In accordance with the Memorandum of Understanding between our agencies, on October 1, 2020 I requested that you review the Japanese Certificate of Approval No. J/170/B(U)F-96, Revision 3, for the JRC-90Y-950K package and make a recommendation concerning our revalidation of the package for import and export use (Docket No. 71-3036 and EPID L-2020-DOT-0000). On February 8, 2021, you sent a Request for Additional Information (RAI) regarding this review.

Answer for the request of JRF-90Y-950K validation from NRC

Kyoto University August 27, 2021

Fig. 0 Dimensions of rectangular pipe Tolerances on all dimensions shall

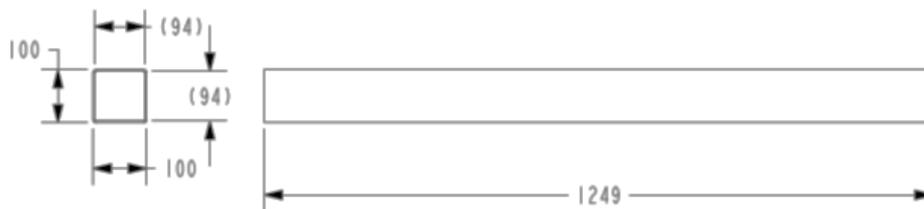
Revise the application to specify the thickness, including tolerance, of the rectangular stainless steel pipes that make up the fuel basket.

The staff needs this dimension in order to perform confirmatory criticality calculations for the package design. This dimension does not appear in the general arrangement drawings or description of the packaging in SAR Section C.

The dimension of one rectangular stainless steel pipe is shown in under figure. The outer dimension is 100 mm square and inner dimension is 94 mm square. Therefore, the thickness is 3 mm.

- One place decimal: +/- 0.8
- Two place decimal: +/- 0.2

Fig. 2 Results of numerical investigation of coupon

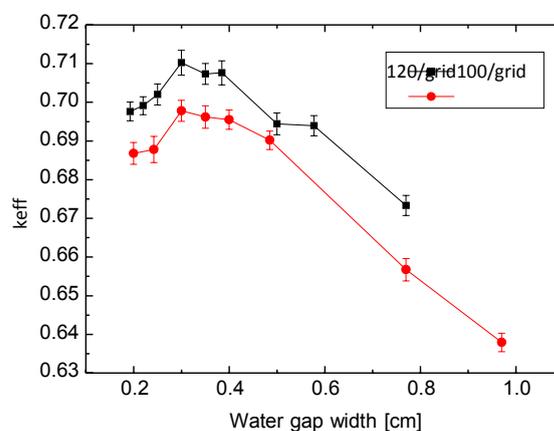
Revise the application to demonstrate that content loads less than the maximum requested will remain subcritical.

SAR Table A.1 states that the number of Kyoto University Critical Assembly (KUCA) fuel elements is 1,200 or less for coupon elements, and 300 or less for flat elements. However, the criticality analysis only demonstrates that the maximum load for each element type is subcritical. Lower numbers of elements may allow for greater spacing between elements with a more optimum degree of moderation, and therefore a higher system keff. Initial staff confirmatory analyses indicate that k-effective (keff) is higher for lower numbers of plates at an optimized pitch. The analysis in the SAR should demonstrate that all allowable content loads, up to the maximum requested, remain subcritical under all conditions.

The question is related the optimum degree of moderation for neutron. Therefore, the effect of gaps and number of elements was numerically investigated by changing these factors.

For the investigations, coupons were set at the center of pipe and the gaps between each coupon were evenly spread (Fig.1). The yellow part of Fig. 1 is water and the boundary is perfect reflection. Then, the gap was changed maximum space case (0.77 mm@1,200 coupons) to narrow space case. Also, the cases of 1,200 coupons and 1,000 coupons were investigated. The results of numerical investigation were shown in Fig. 2. The 1,200 coupons case has higher k-effective than 1,000 coupons case. And the optimum gap is 0.3 mm. It indicated the greater spacing between coupons do not have more optimum degree of moderation. Therefore, the 1,200 coupons case has maximum k-effective. In the SAR, the coupons were shifted to the center of the basket and gap was set at 0.4 mm (it was investigated such as same way).

Fig. 5 Calculation system for coupon surrounded by silicone rubber

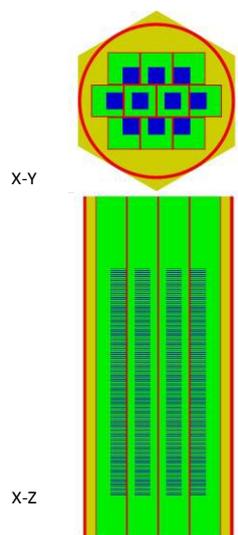
Revise the criticality analysis to consider hydrogen-bearing material other than water that may be present in the package with the fissile material contents.

SAR Section D.3 states that KUCA fuel contents are “wrapped by some buffer such as polyurethane foam,” and that “silicone rubber spacers are used to the upper and lower sides of the fuel plates in order to absorb possible impact energy during transport, and also to fix the fuel plates.” The criticality analysis in Section E of the SAR only considers water as a possible moderator. The hydrogen-bearing materials discussed in Section D.3 can have a higher hydrogen density than water for a given mass and may be more effective moderators than water. The criticality analysis should be revised to consider the moderating effects of these materials, including consideration of any reconfiguration of the materials under accident conditions (e.g., melting).

The atomic density of hydrogen in silicone rubber is close to that of water and silicone rubber includes carbon. Therefore, calculation was performed by replacing water with silicone rubber. The green part of Fig. 5 and 6 is silicone rubber and the other calculation conditions were same as water case. The results of k-effective are shown in Table 1. The k-effectives of water moderator case are higher than silicone rubber case in both coupon and flat plate. It demonstrates the analysis of water moderator includes that of silicone rubber case.
